ALERT SERVICE BULLETIN

**SUBJECT: REVISION "C" TO ALERT SERVICE BULLETIN ASB 206-07-115:
POWER TURBINE RPM (N2) STEADY STATE OPERATION
AVOIDANCE, INTRODUCTION OF.**

NO. 206- 07-115

REV C

Figure 1- Typical 206B Instrument Panel Layout
 (May vary depending on model and serial number applicability)

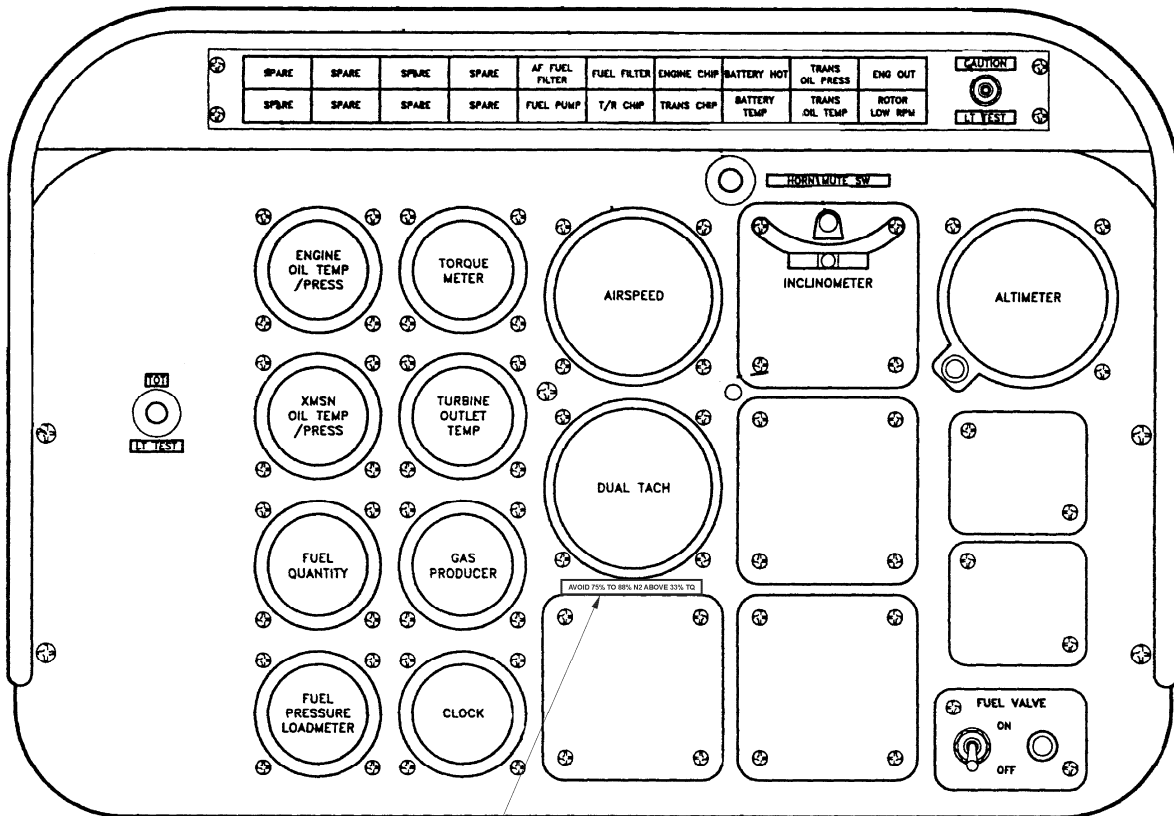
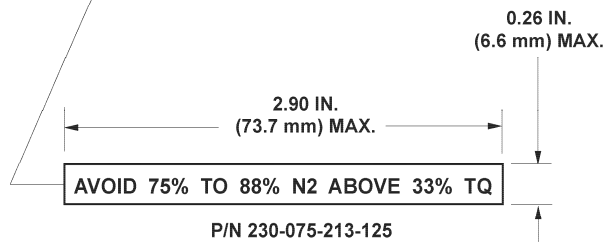
Revision "C" to this bulletin introduces a new decal removing the "60 SEC MAX" wording.

1. One decal is provided with this bulletin.
2. The decal may be locally manufactured using lettering of white color (No. 17875) on black background color (No. 17038). Characters to be 10 point Spartan blackfont. Color per FED STD 595. The text for the decal is detailed in Figure 1 and should be in capital letters. It is permissible to use existing decal provided the "60 SEC MAX" wording is cut and removed.

1. Remove previously installed 230-075-213-121 decal and discard.
2. Install 230-075-213-125 decal on the instrument panel as shown in Figure 1 below the NR/N2 dual tachometer. Sealer C-349 shall be applied over the installed decal.
